## Application for Licence Amendment

<b>Licence Number</b>	L9293/2021/1
<b>Licence Holder</b>	Silver Lake (Rothsay) Pty Ltd
<b>ACN</b>	151 137 450
<b>File Number</b>	DER2021/000158
<b>Premises</b>	<p>Rothsay Gold Project</p> <p>Mining Tenements M59/39, M59/40 and L59/24</p> <p>PERENJORI WA 6620</p> <p>As defined by the Premises map attached to the Revised Licence</p>
<b>Date of Report</b>	13 February 2023
<b>Decision</b>	Revised licence granted

**Figure 2: Evaporation Pond monitoring bore Standing Water Level (SWL)**

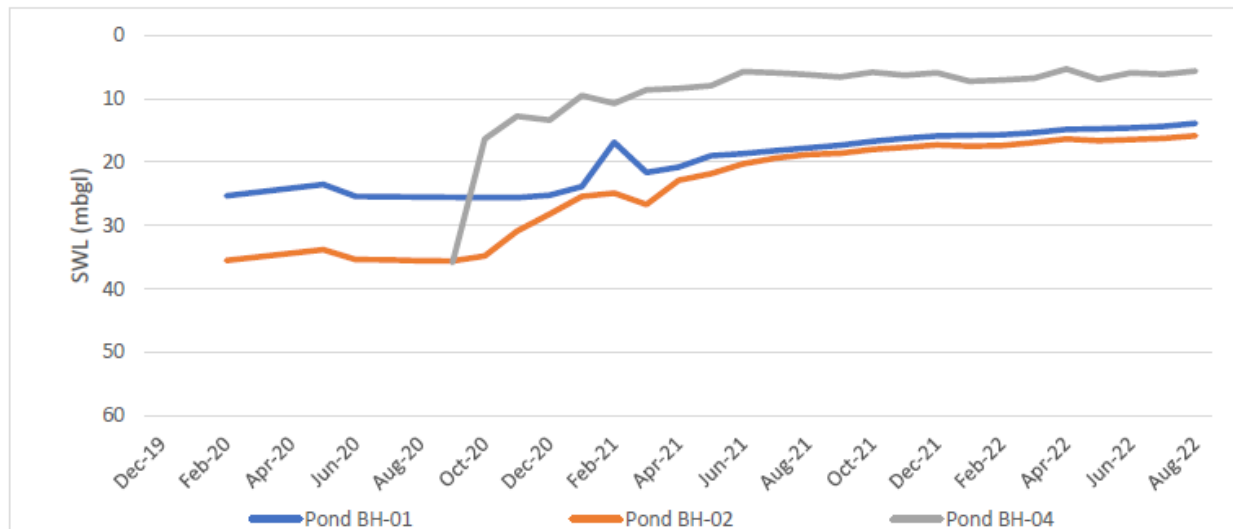
As shown in Figure 2 groundwater levels for monitoring bores in close proximity to the evaporation pond have risen (ranging between 6 m -16 m below ground surface) since dewater discharge commenced and discharge to the ephemeral drainage line ceased (cessation due to TDS levels above licence discharge limit – refer to Table 3).

To ensure groundwater with elevated TDS is not impacting the root zone of vegetation adjacent to the evaporation pond, the Licence Holder is proposing that Warning and Action Trigger levels associated with SWL are applied to monitoring bores Pond BH-01; Pond BH-02; and Pond BH-04 (refer to section 3).

Seepage through the base and walls causing groundwater mounding and contaminating groundwater	Groundwater suitable for stock quality 50 mbgl	Refer to Section 3.1	C = Moderate L = Possible <b>Medium Risk</b>	Y	Condition 14 on existing licence relating to monitoring of ambient concentrations for the evaporation pond bores.	During this amendment condition 14 has been updated to include Pond BH-01, Pond BH-02 and Pond BH-04 under the Warning and Action Trigger Levels for SWL as requested by Licence Holder.

**Figure 3: WWTP upgrade design**

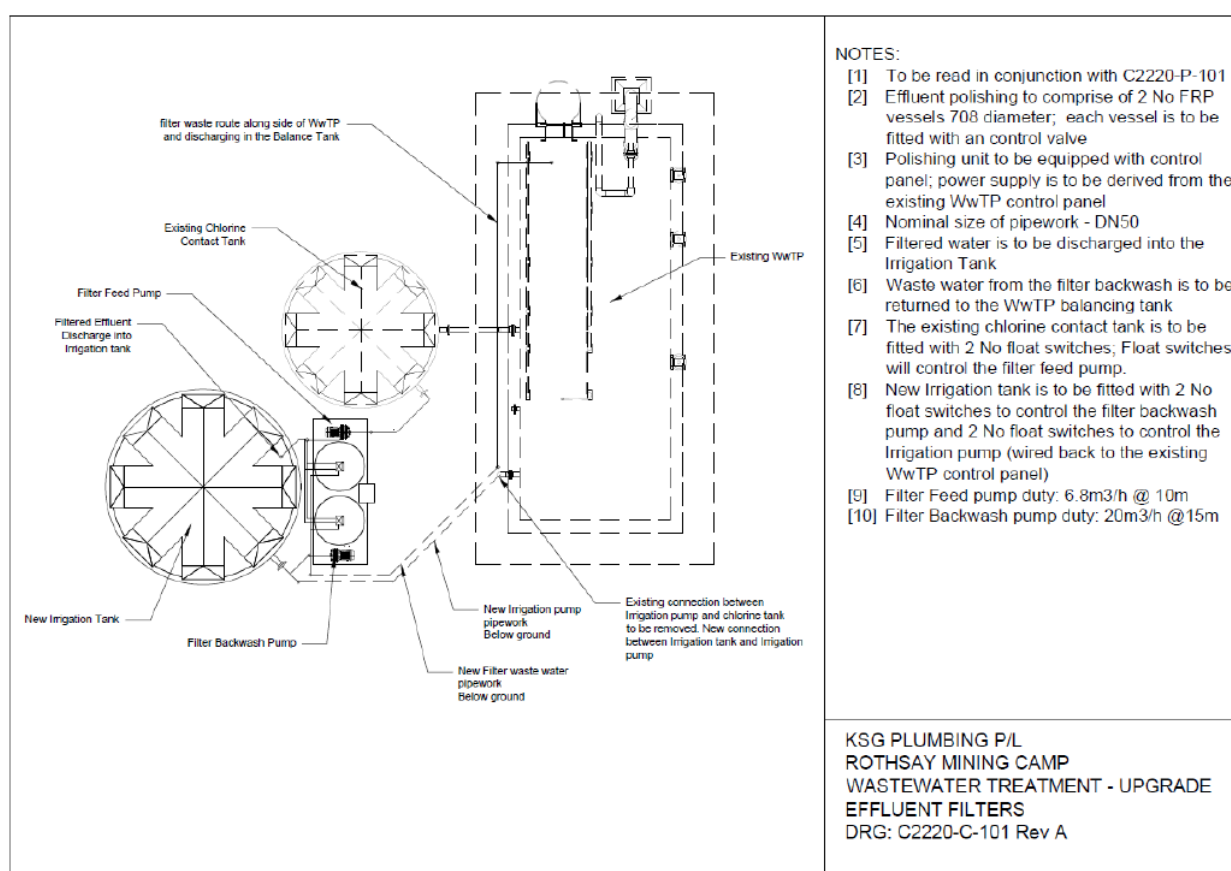
The Licence Holder has identified that an effluent polishing unit is required to assist with achieving design quality parameters. With the inclusion of the polishing unit, the maximum design capacity of the WWTP has been estimated at 35 m<sup>3</sup>/day. Treated effluent results compared to design wastewater outputs are shown in Table 5.

The Licence Holder has also reviewed their sprayfield discharge and identified that additional sprinklers installed within the existing footprint will allow for greater flexibility to improve distribution of treated wastewater.
